# **SIERRA CLUB COMMENTS ON PUGET SOUND ENERGY FINAL 2023 GAS INTEGRATED RESOURCE PLAN**

Puget Sound Energy’s 2023 gas Integrated Resource Plan is the Company’s first gas plan filed since Washington enacted the Climate Commitment Act (“CCA”) in 2021. This landmark legislation requires gas utilities to plan and implement major decarbonization strategies in line with the state’s emission reduction targets. Unfortunately, PSE’s IRP fails to align with the CCA’s decarbonization targets and requirements. The plan includes a preferred portfolio that relies almost exclusively on purchasing CCA allowances, rather than pursuing available decarbonization strategies like building electrification.

Figure 1: PSE Preferred Portfolio Allowance Needs<sup>11</sup>

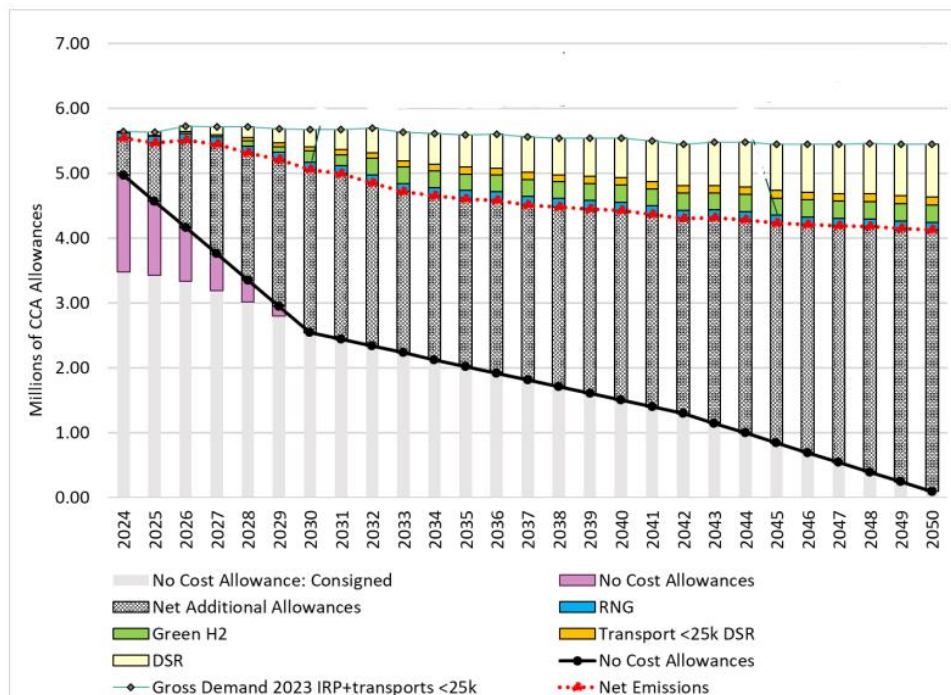
As shown in Figure 1 below, PSE proposes to purchase an increasing number of allowances that reaches over 4 million in 2050. This exceeds the total number of emissions that the Washington State Department of Ecology (“Ecology”) expects to be available *for the entire state* in that year, since the number of available allowances declines each year to align emissions with state decarbonization targets (see Figure 2 below). The same is true for 2049.<sup>10</sup> In these years, it is virtually guaranteed that allowances available through auction will be exhausted, and PSE will need to purchase its allowances at the ceiling price pursuant to RCW 70A.65.160(2), contrary to its assumption that those allowances will be available at a mid-level price.

Figure 3: PSE Required Allowances Compared to Purchase Limit<sup>13</sup>

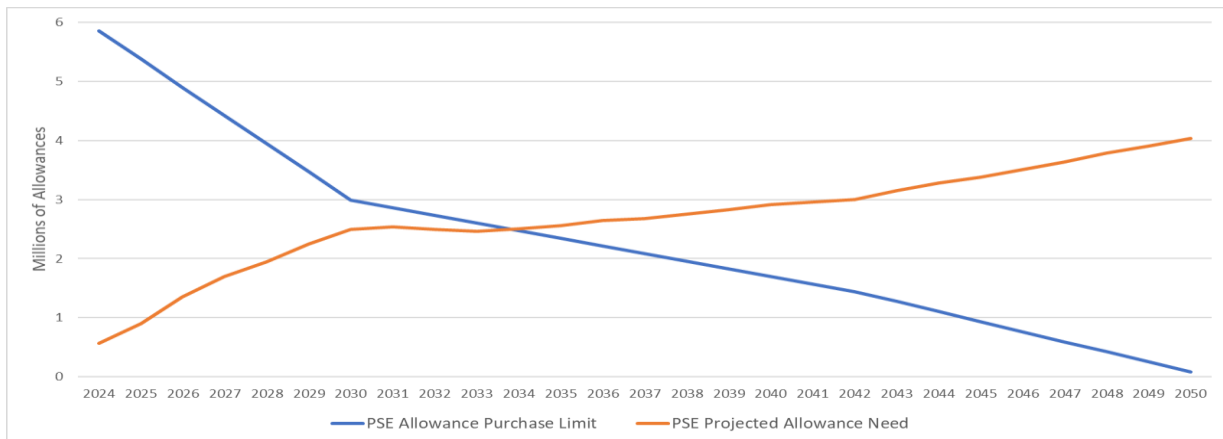
Similarly, PSE’s preferred portfolio relies on significant allowance purchases in excess of the purchase limits set forth in WAC 173-446-330(1). Generally, these purchase limit rules prevent any individual entity from buying more than 10% of the total available allowances. As shown in Figure 3 below, PSE’s preferred portfolio exceeds the purchase limit by an increasing amount beginning in 2034. This gap widens to a shortage of over a million allowances by 2040, and nearly 4 million by 2050.

Figure 4: Comparison of Real and Nominal CCA Prices Through 2050

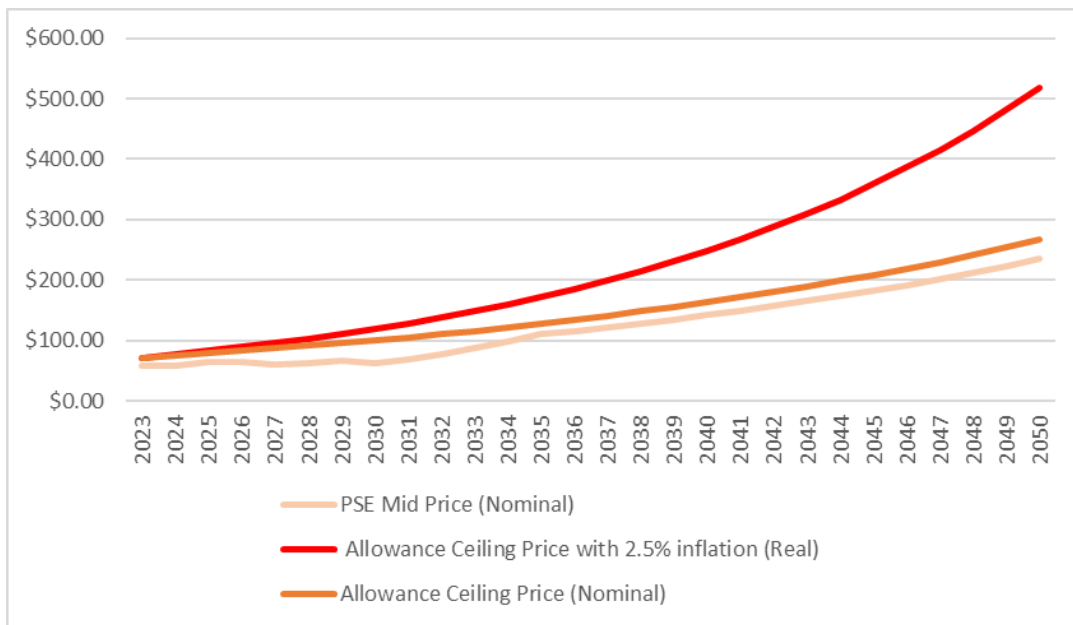
PSE miscalculates allowance prices in its IRP by failing to include inflation, causing it to underestimate the net present costs of its preferred portfolio by as much as \$1.91 billion over the analysis period. In the Company’s price forecast, displayed in Figure 4.7 of the IRP, the Company reports CCA allowance prices that increase from about \$72 in 2023 to about \$266 in 2050—an increase of 5% per year. PSE reports these allowance costs as “nominal \$ /metric ton CO2eq.”<sup>22</sup> This is incorrect; Ecology rules state that allowance prices will increase by 5% annually *plus* the rate of inflation.<sup>23</sup> Nominal values would be 5% plus a measure of annual inflation. The values reflected in PSE’s Figure 4.7 reflect real values, not nominal values. This is problematic because PSE compares its real allowance price values to the nominal values of other decarbonization measures, and performs calculations that assume all values are nominal.

Figure 4 below shows the significant impact of PSE’s miscalculation. If PSE assumes a 2.5% rate of inflation as it does elsewhere in the IRP,<sup>24</sup> nominal allowance prices in 2050 are roughly twice as much as PSE’s analysis assumed.

Figure 5: Comparison of Actual Natural Gas Prices at Sumas, WA with PSE’s 2021 IRP gas forecast<sup>29</sup>

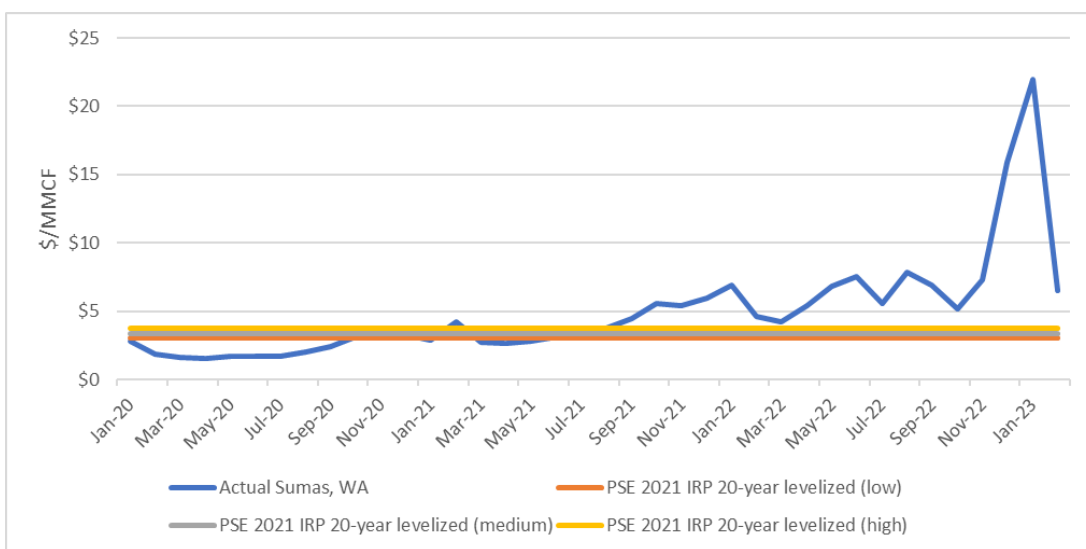
Finally, under PSE’s preferred portfolio, customers remain exposed to significant risks of volatile and increasing gas prices (and to the even higher and more uncertain costs of alternative fuels, to the extent the portfolio relies on them). Changing geopolitical and economic conditions have led to significant gas price surges in the Pacific Northwest. Since PSE submitted its 2021 IRP, gas prices have soared far beyond PSE’s projections, as shown in Figure 5 below. Moreover, gas suppliers must also comply with the CCA, so if PSE’s strategy increases allowance prices as discussed above, it may make compliance more expensive for gas suppliers, resulting in higher gas prices that are passed on to PSE’s customers. Greater investments in building electrification, energy efficiency and conservation, and demand response can help reduce ratepayers’ exposure to gas price risk under the preferred portfolio.
